Application for Final Development Plan

| *REQUIRED INFORMATION: All correspondence will be addressed to | the applicant |
|--|--|
| *Name of Final Development Plan: The Goddard School | |

STAFF COMMENTS

PLAN REVIEW

Turning Performance Analysis

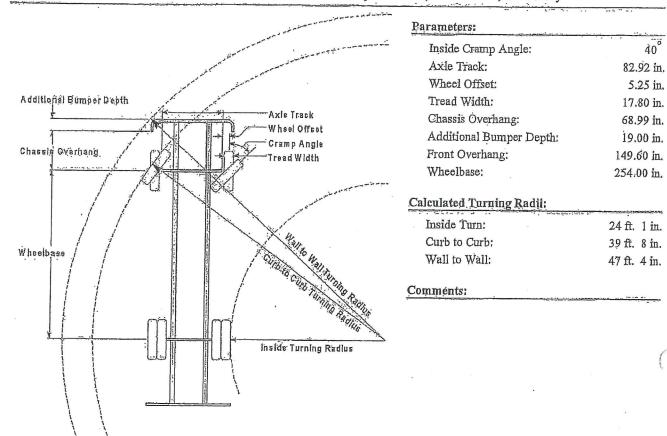
ACTION REQUIRED: A turning performance analysis shall be provided from the fire apparatus manufacturer.
